## Epping Bridge Project Feedback

Thank you for the opportunity to comment on the Epping Bridge Project (*The Plan*).<sup>[1]</sup>

These comments have been prepared on behalf of CAMWEST, a Bicycle NSW affiliated Bicycle User Group (BUG) with a focus on advocating for and encouraging cycling in Western Sydney. The Epping area overlaps with our neighbouring BUG Bike North who may also provide some feedback.

Marked-up Cycling layer enabled Open Street Map image of current cycling routes around the Epping Station precinct.

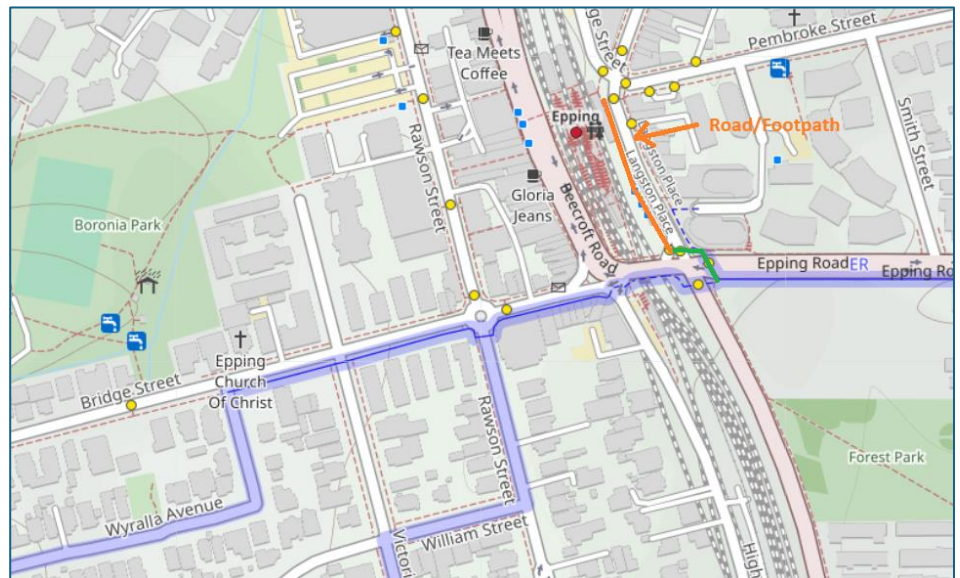
At present there is no recognised safe access cycling route to Epping station staying on the western side of the line, despite potential routes using Boronia Park or Victoria St through to the walkway that leads to Beecroft Rd near the pedestrian overbridge. Currently some riders walk their bikes along Beecroft Rd between the Bridge St shared path and the pedestrian overbridge lift to access the station.

On the eastern side of the bridge there is the 'missing leg' of the Blaxland Rd/Langston Place intersection, with users required to cross 3 legs of the intersection with only the Epping Rd crossing leg having bicycle lanterns. Despite containing bike parking, the path along the

western side of Langston Place has no markings to indicate that it may be a shared path.
